NOTICE OF DECISION

PARTITION TENTATIVE PLAN / VALIDATION OF UNITS OF LAND CASE NO.:
PAR-VUL23-06

LOCATION: 848 Mildred Ln SE, Salem OR 97306

OSBORN
PARTITION

SHADOW PLAT
BILTMORE LANE
STREET PLAN
AND PROFILE

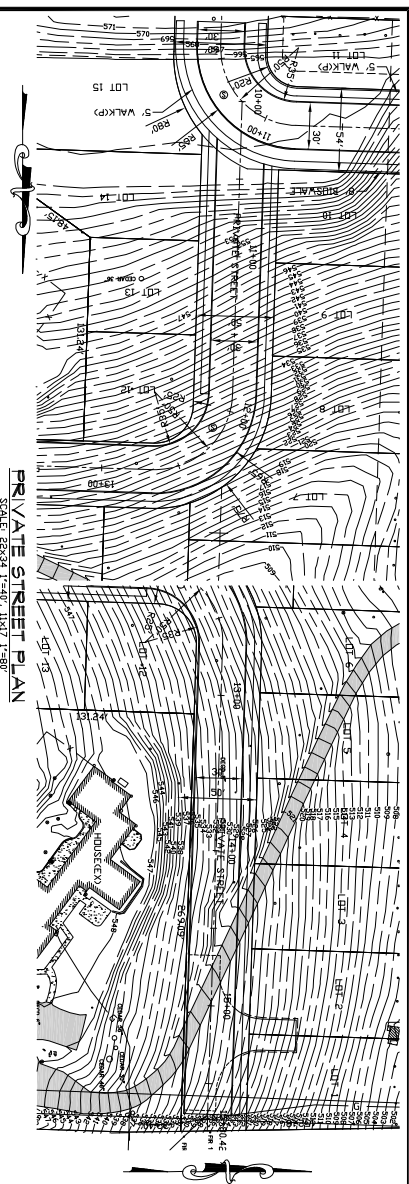
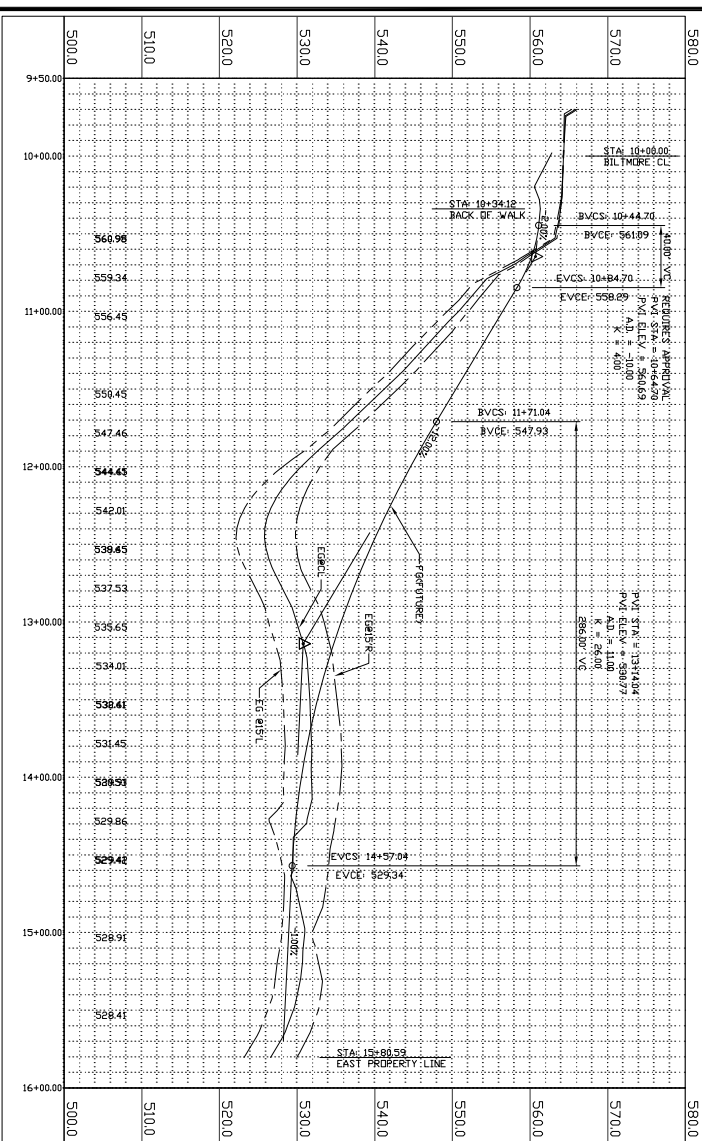
Biltmore Ave SE terminates at the western property boundary and is intended to extend through the development site for an eventual east-west connection to Stubb St SE, southeast of the development site. The applicant provided a future development plan that shows this eventual connection; however, it is not clear from the information submitted whether or not the design can conform to SRC Chapter 803 and PWDS for local street construction. Pursuant to SRC 803.035(a) local streets shall be extended to adjoining undeveloped properties for eventual connection with the existing street system. As a condition of approval, the applicant shall be required to provide a conceptual engineered design for the street through the development site that meets SRC Chapter 803 and PWDS for local street construction. Based on the approved design, the applicant shall also be required to dedicate an easement to the City for roadway and utilities that will be converted to right-of-way when Parcel 2 is further subdivided, and the street extension is constructed. As conditioned, this criterion is met.

Biltmore Avenue SE terminates at the western property boundary and is intended to extend through the development site for an eventual east-west connection to Stubb Street SE, southeast of the development site. The applicant provided a shadow plan that shows this eventual connection, however; it is not clear from the information submitted whether or not the design can conform to SRC Chapter 803 and PWDS for local street construction. Pursuant to SRC 803.035(a) local streets shall be extended to adjoining undeveloped properties for eventual connection with the existing street system. As a condition of approval, the applicant shall be required to provide a conceptual engineered design for the street through the development site that meets SRC Chapter 803 and PWDS for local street construction. Based on the approved design, the applicant shall also be required to dedicate an easement to the City for roadway and utilities that will be converted to right-of-way when parcel 2 is further subdivided and the street extension is constructed.

Condition 9: Provide a conceptual engineered design of the horizontal and vertical alignment of the extension of Biltmore Ave SE through the development site.

Condition: Provide a conceptual engineered design of the horizontal and vertical alignment of the extension of Biltmore Avenue SE through the development site.

**TREE PRESERVATION
PLAN**

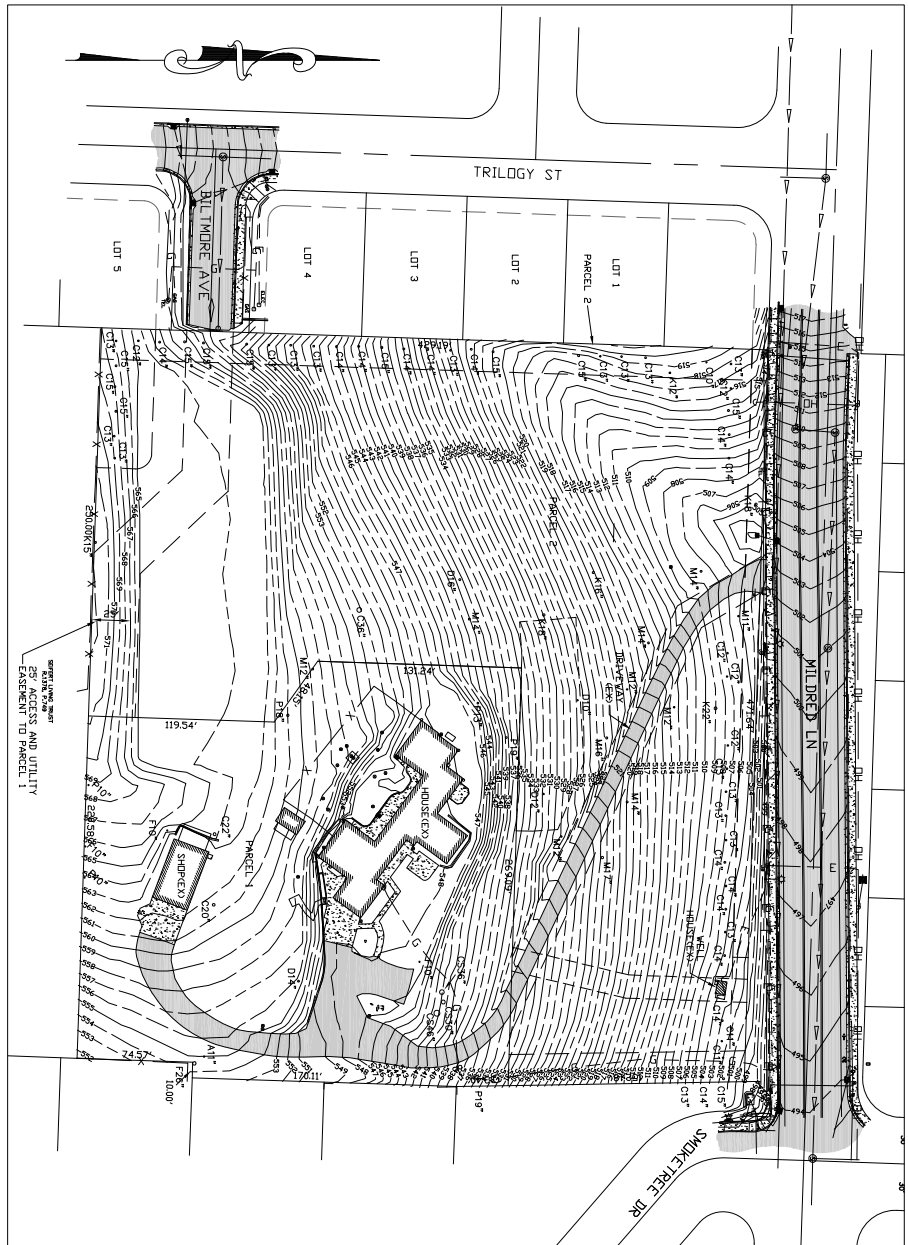
Finding: The applicant provided a tree preservation plan for the subject property proposing the preservation of all trees on the property. Of the 98 trees identified on the plan, four are considered significant; there are no identified riparian corridor or heritage trees on site. In order to comply with the requirements of SRC 808, the applicant shall apply and gain approval of a tree conservation plan, as outlined in SRC 808.035.

Condition 3: Prior to final plat approval, the applicant shall submit and be approved of a Tree Conservation Plan, as outlined in SRC 808.035.
